INITIAL FIRE SAFETY INSPECTION REPORT

SHINE EMBROIDERY LTD

RSC ID: 24648

Date: 5 March, 2024

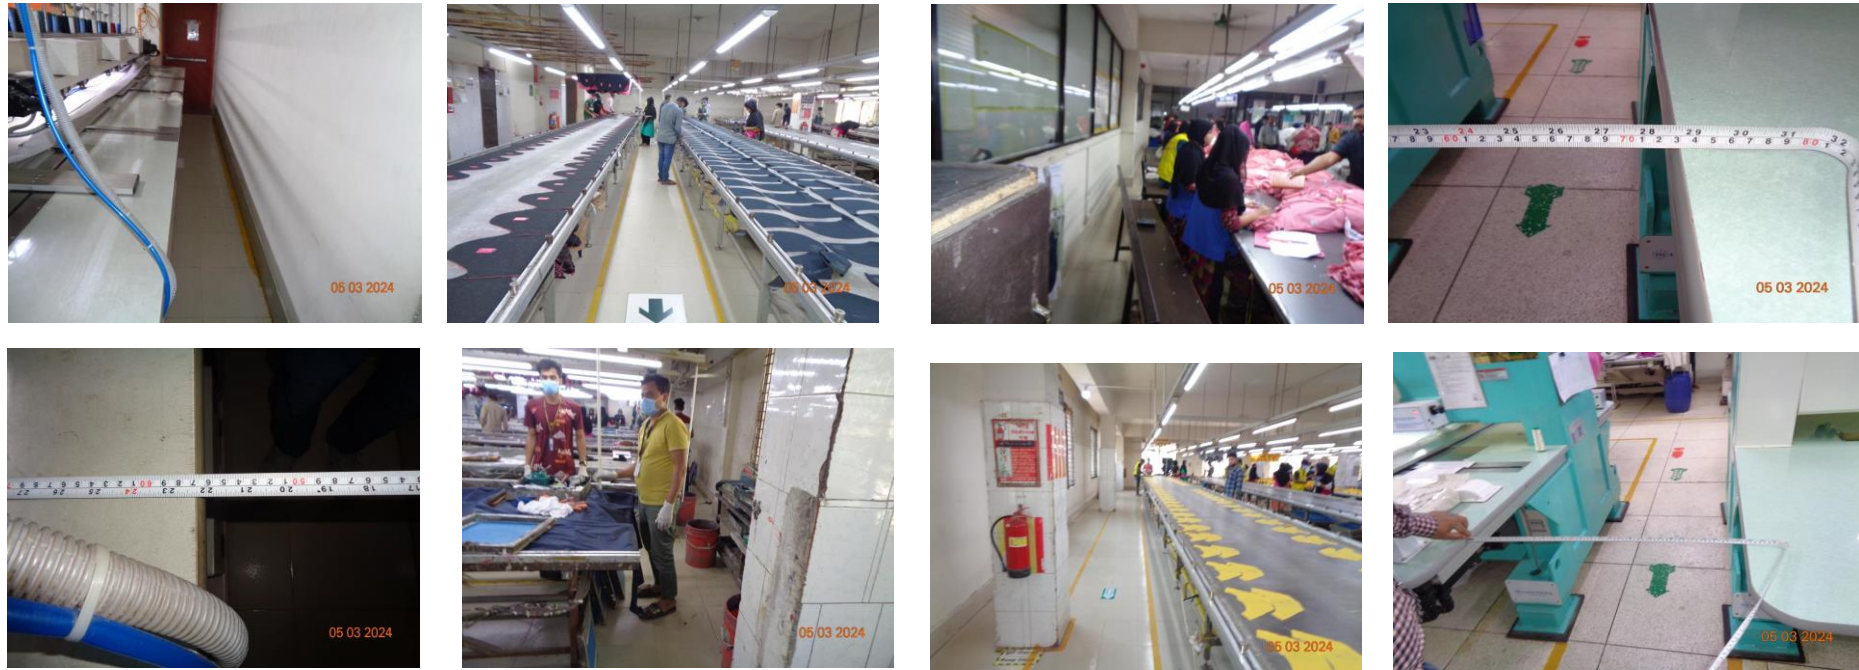
F-5	Mean of Egress	Aisles were found missing on several locations & aisles were found less than 36 inch throughout the building.	Provide minimum aisle widths of 36-in. Aisles mark shall be clearly visible. Aisles shall be free from all obstruction , storage & process work.	Within 3 months
-----	----------------	---	--	-----------------

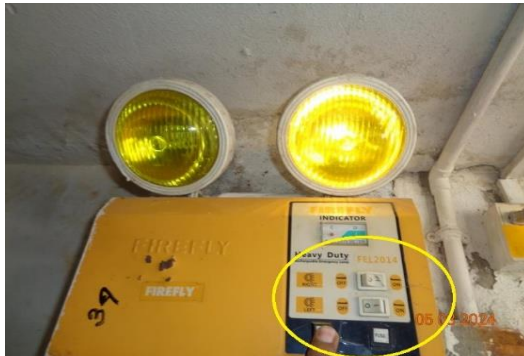
F-8	Emergency Lighting	Manual on-off switch is provided for exit signage at the door to the egress on all floors.	Remove manual on/off switches from exit signage units to prevent them from being switched off.	Within 1 month
-----	--------------------	--	--	----------------
